SECTION 905 -- PROPOSAL (CONTINUED)

| Number | Description |
|--------|---|
| 1 | Revise Table of Contents, replace same; Add NTB Nos 4658, & 4662; Revise Bid Items, replace same; Add or Revise Plan Sheet Nos. 2-3, 5, 8, 11-12, 14, 19, 28, 53, 55, 87, 8001-8004, 8006, 8008-8009, 8011-8013, 8017, 8019, 8027, 8029-8030, 8032, 8034-8037, 8042, 8048-8051, 8053, 8055-8056, 8062, 8068; Amendment EBS Download Required. |

BR-0019-02(041) / 105189301

Bridge Replacements on SR 7 at Bridge Nos. 154.0, 154.8, 155.0, known as Federal Aid Project No. BR-0019-02(041) / 105189301 in Marshall County.

SECTION 1-1
BAR BENDING DETAILS

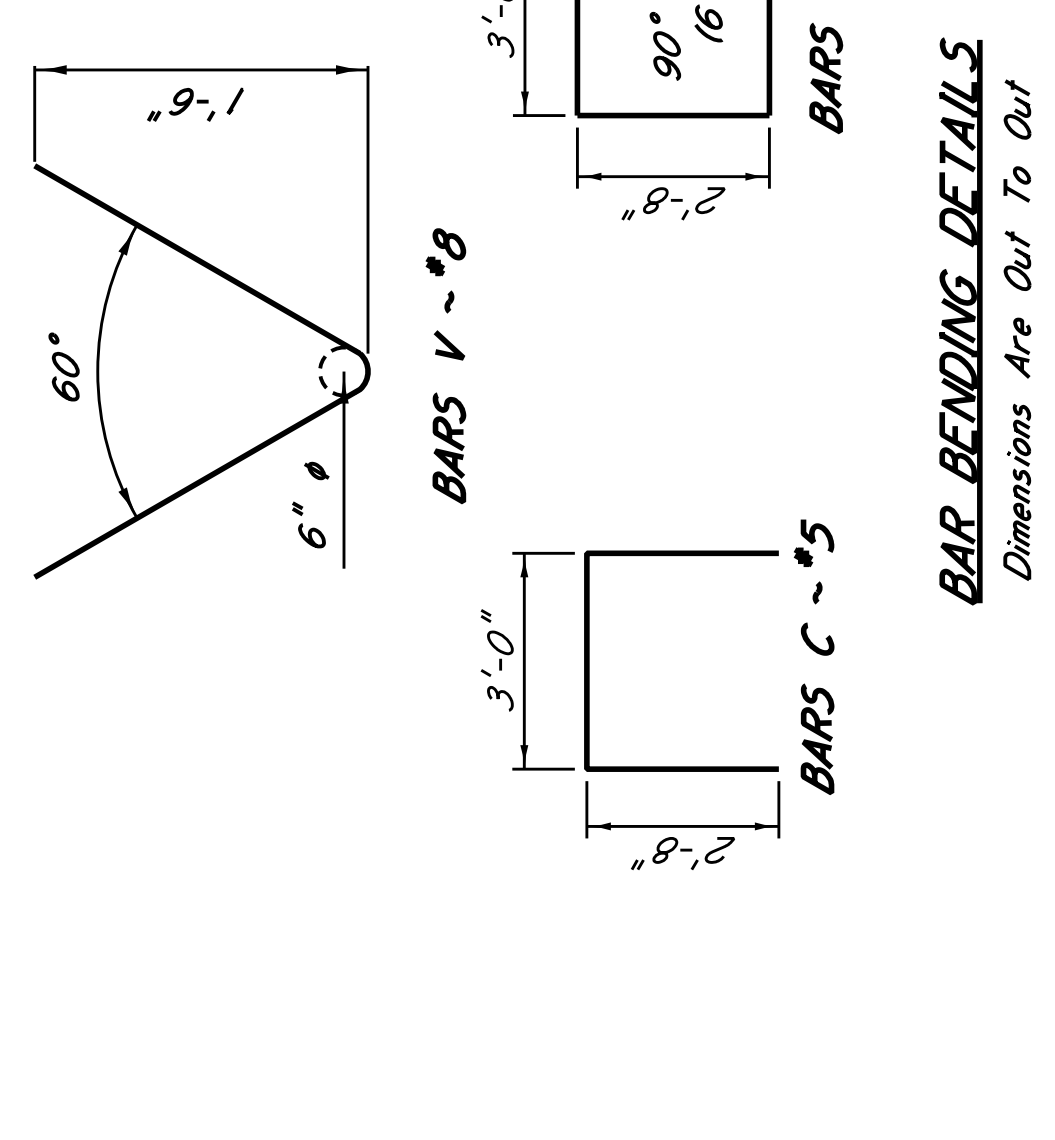
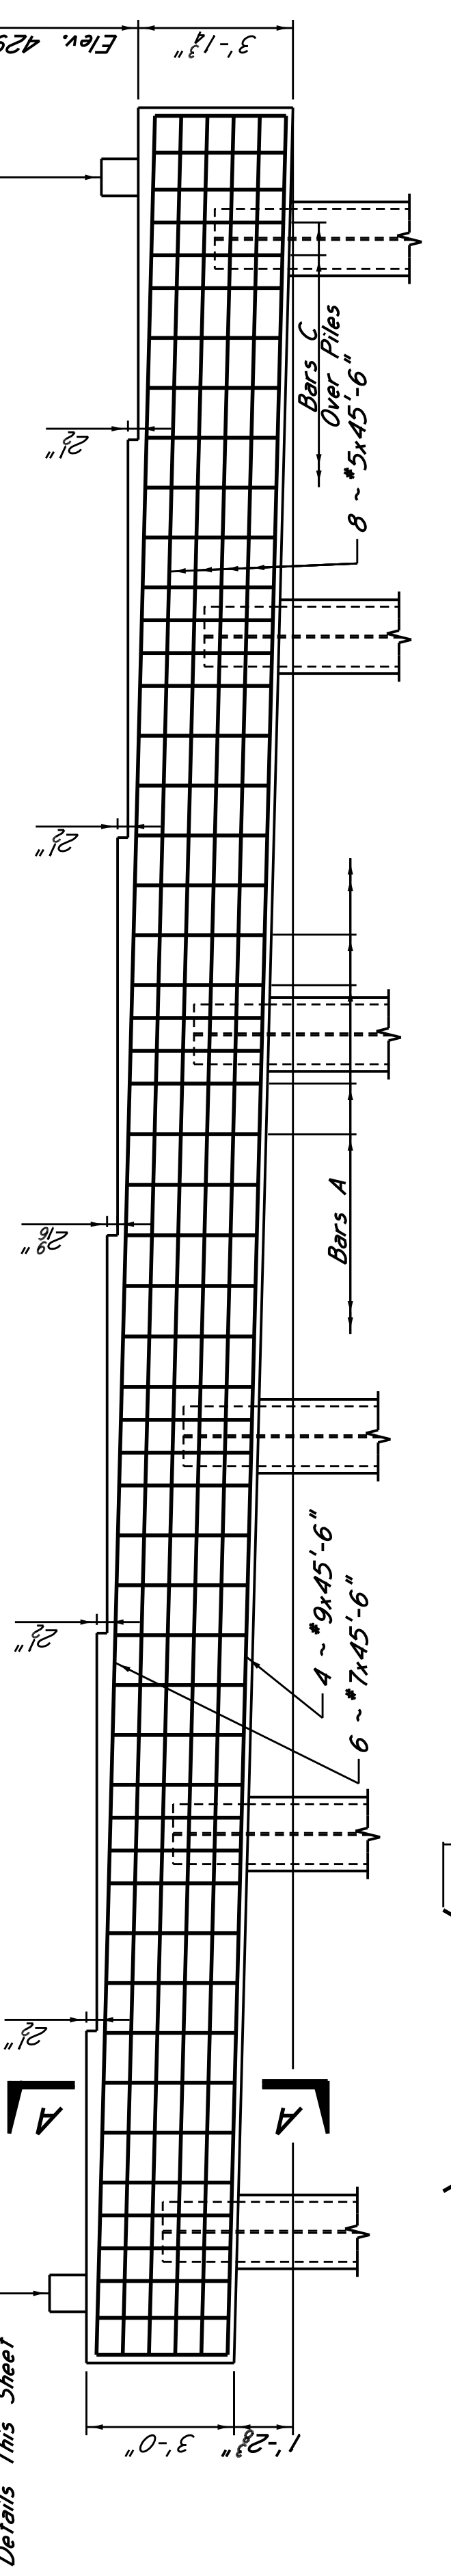
| REVISIONS | | | |
|-----------|------|----|--------------------------|
| 1 | | | Reference & note revised |

MISSISSIPPI DEPARTMENT OF TRANSPORTATION
 BRIDGE AT STA. 229+81.21
 40 FT. SPAN DETAILS
 (SPAN 6 & 7)
 PROJECT BR-0019-02(041)
 MARSHALL COUNTY
 WORKING NUMBER A14 OF 24
 SHEET NUMBER 8017

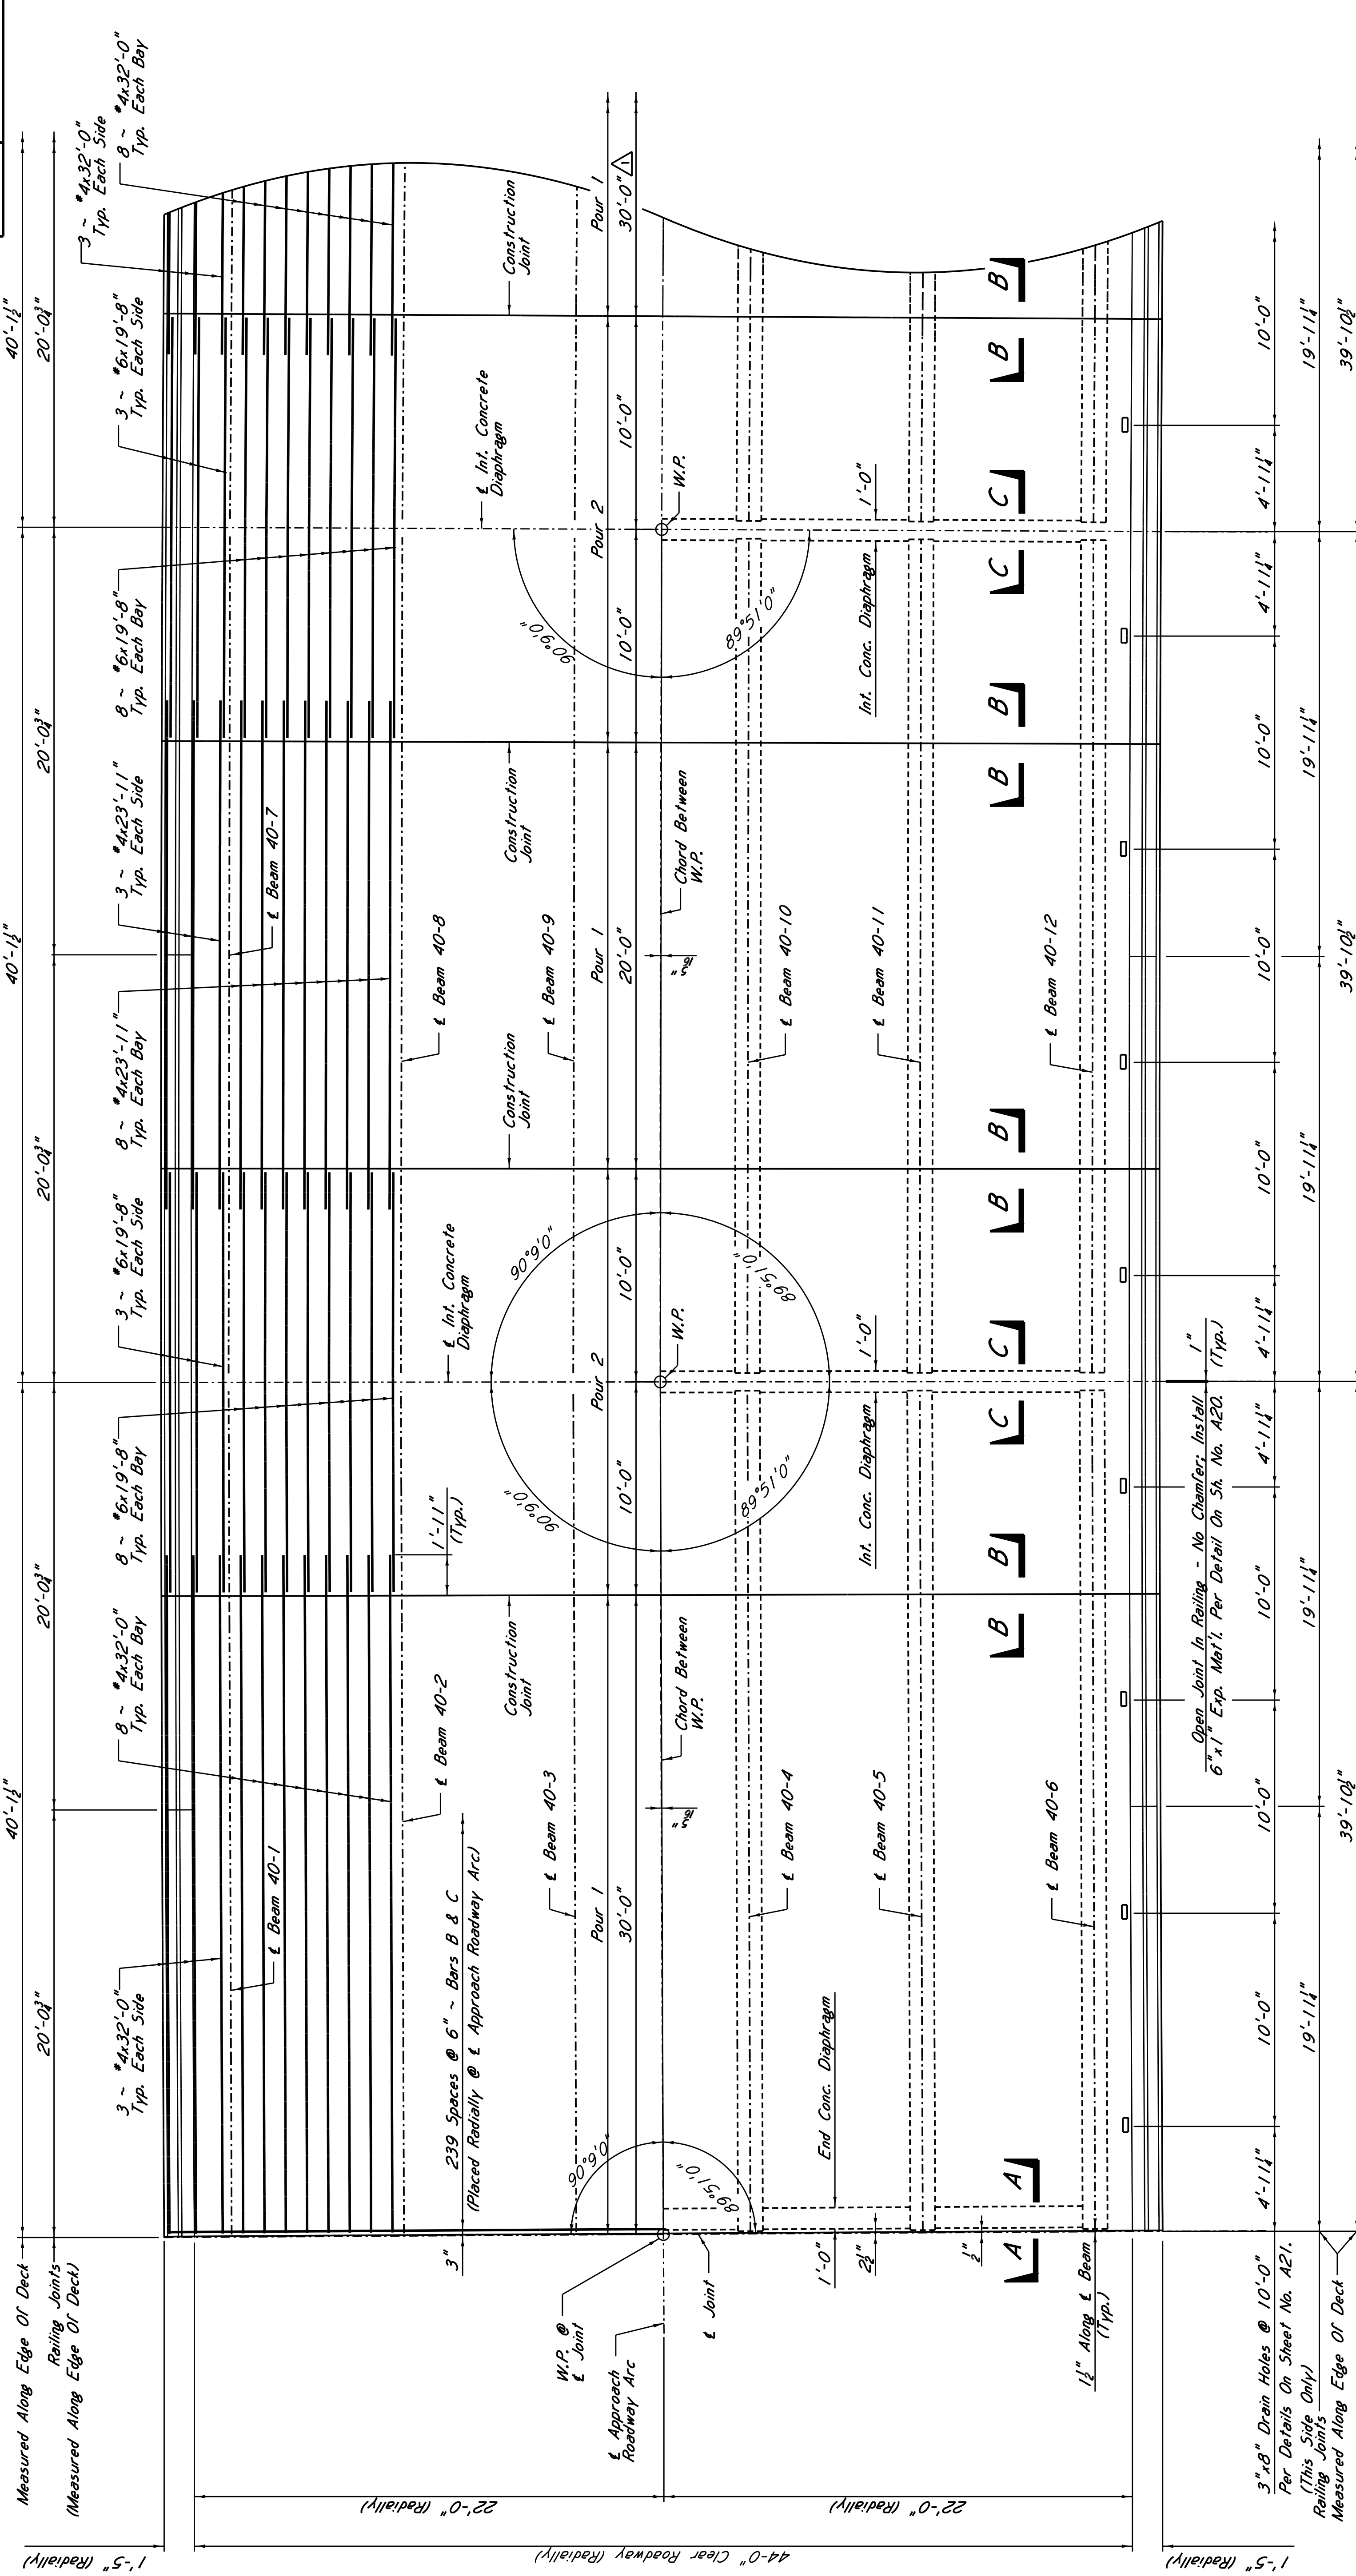
| CHECKER | Dimension revised |

WORKING NUMBER C3 OF 20
SHEET NUMBER 8051

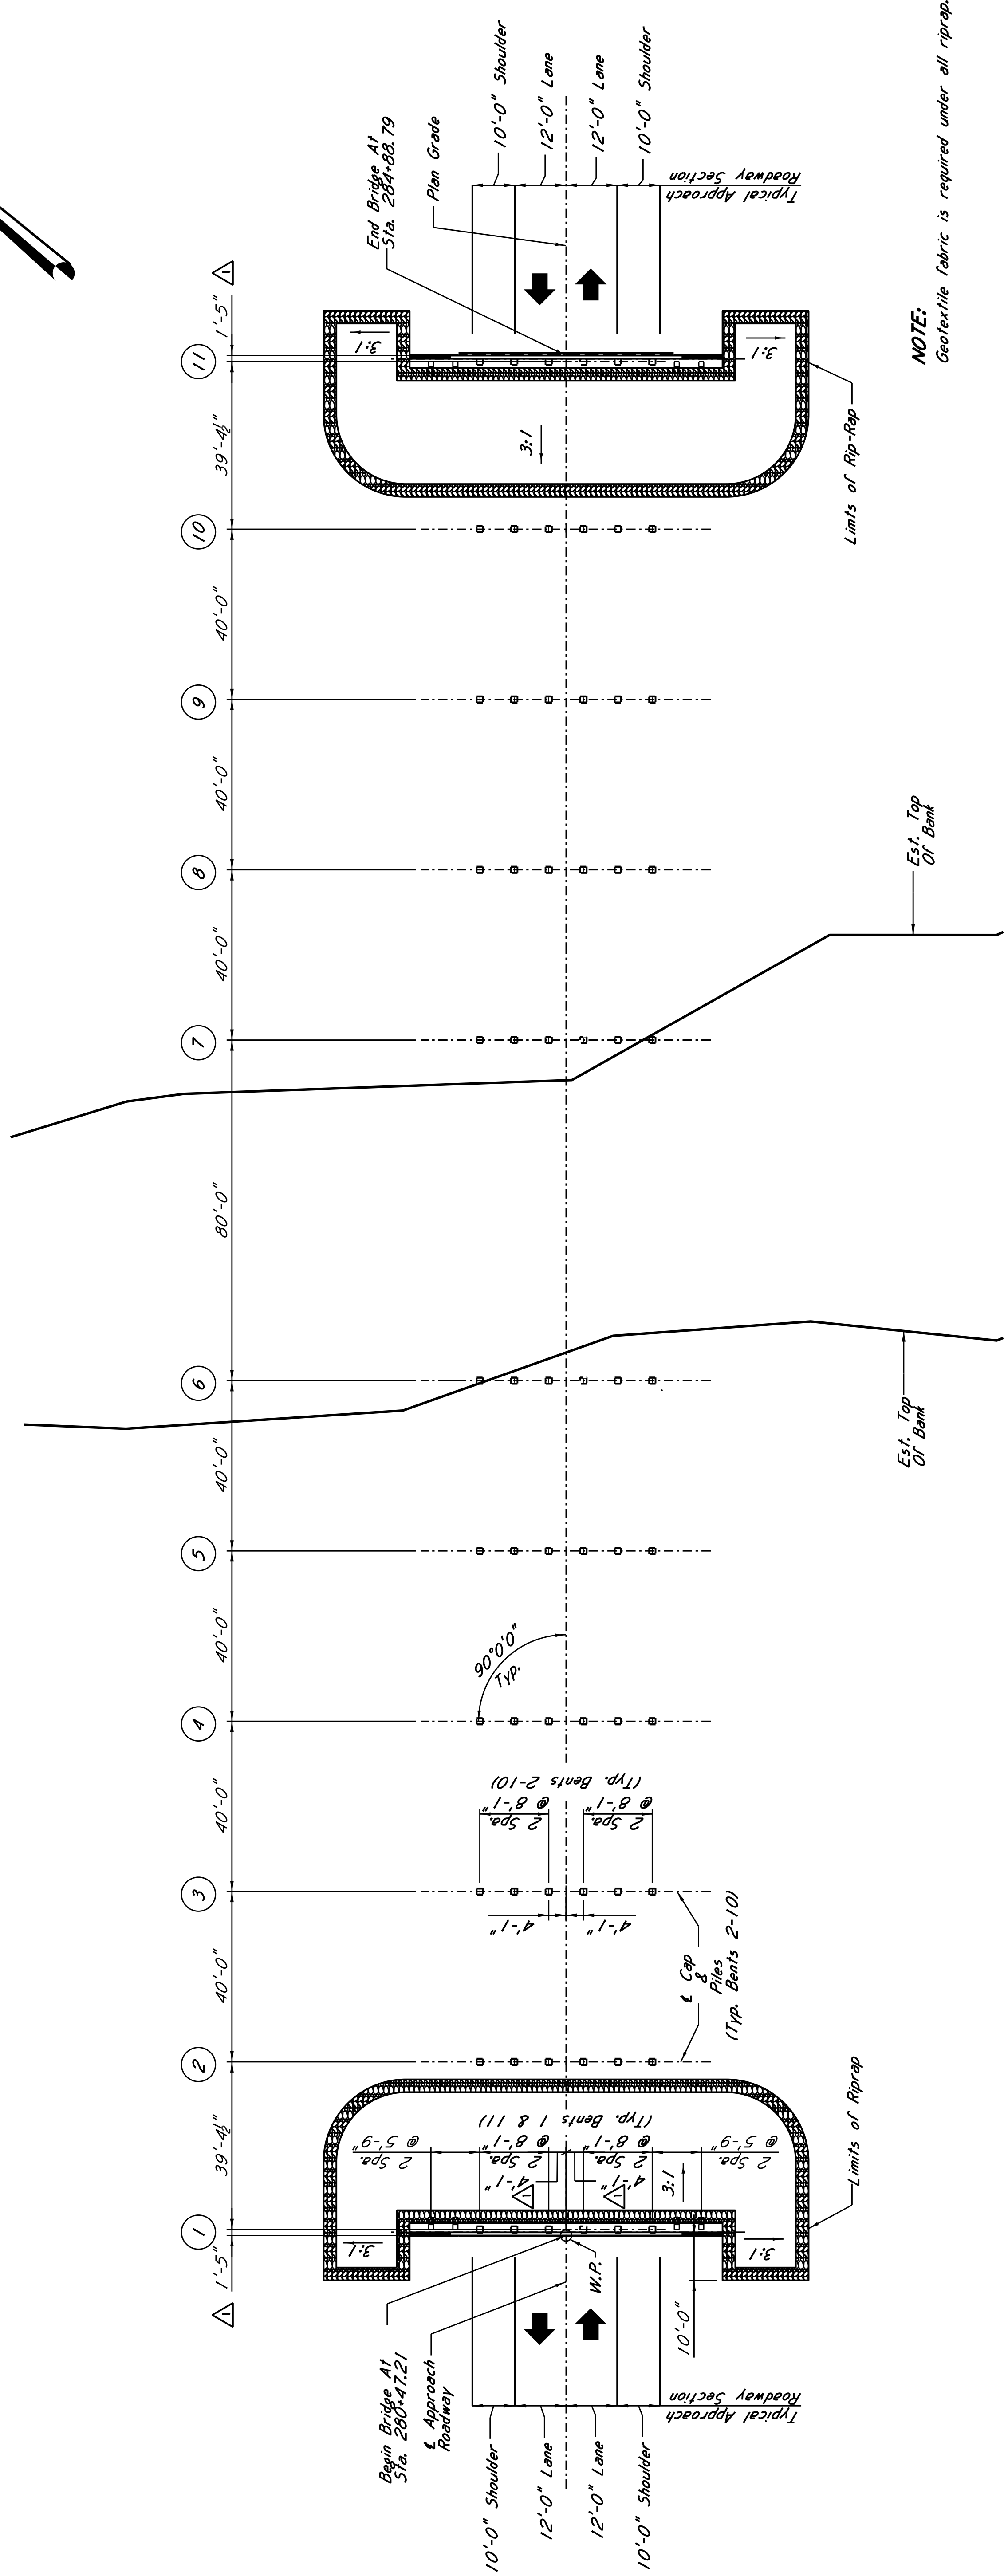
| Dimension revised | | | |
